## PRODUCT/PROCESS CHANGE NOTICE (PCN)

<b>PCN #:</b> TB-0512-01 <b>DATE:</b> 16-Dec-2005 <b>Product Affected:</b> All IDT Products Shipped in <b>Tape &amp; Reel</b>  <b>Date Effective:</b> 16-Dec-2005	<b>MEANS OF DISTINGUISHING CHANGED DEVICES:</b> <input type="checkbox"/> Product Mark <input type="checkbox"/> Back Mark <input type="checkbox"/> Date Code <input checked="" type="checkbox"/> Other                      Reel color changed to black
---	--

### ATTACHMENT I - PCN #: TB-0512-01

### Existing and New Reel Types

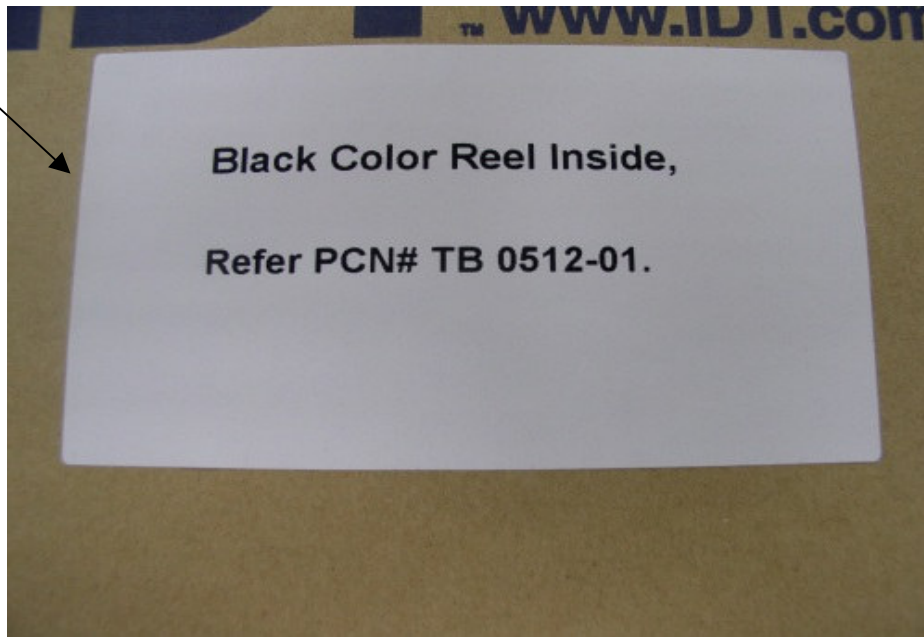
**Detail of Change:** There are no changes in physical or chemical properties for new reel except for the color of the reel. The color will be changed from blue to black.

Description	Existing Reel	New Reel
Supplier	PCT	ExtraPex
Color	Blue	Black
